CITY OF OLYMPIA
Olympia Design Review Board

CONCEPT DESIGN REVIEW
STAFF REPORT
January 26, 2023

Project Name/Number: North Thurston School District RMAC South, Project No. 22-6507

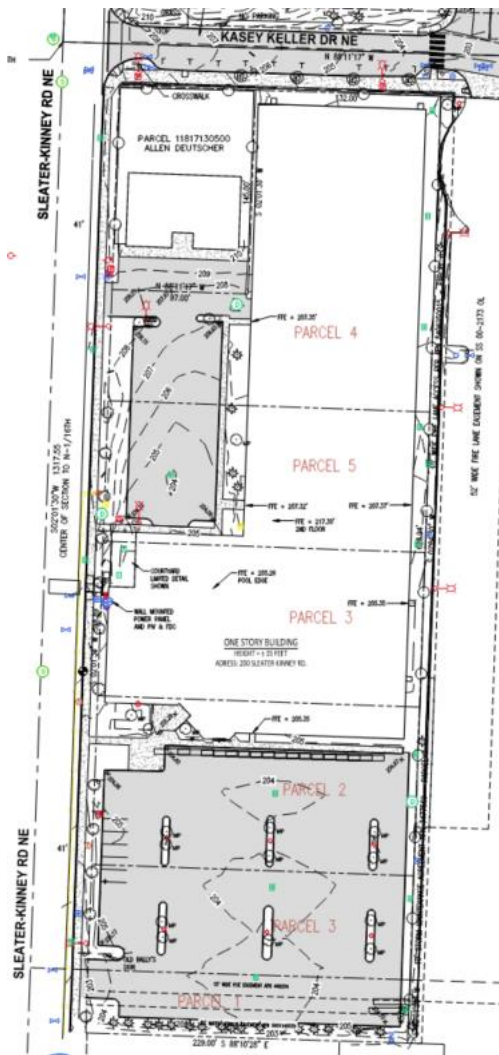
There is currently no pedestrian activation along the Sleater Kinney frontage. The applicant's proposal shows a significant improvement to the pedestrian environment but does so by pulling the building away from the frontage. Staff finds that the proposed extension toward Sleater Kinney is an acceptable way to meet these standards which seek pedestrian activation along the street frontage. The proposed design improves what currently exists at the site.
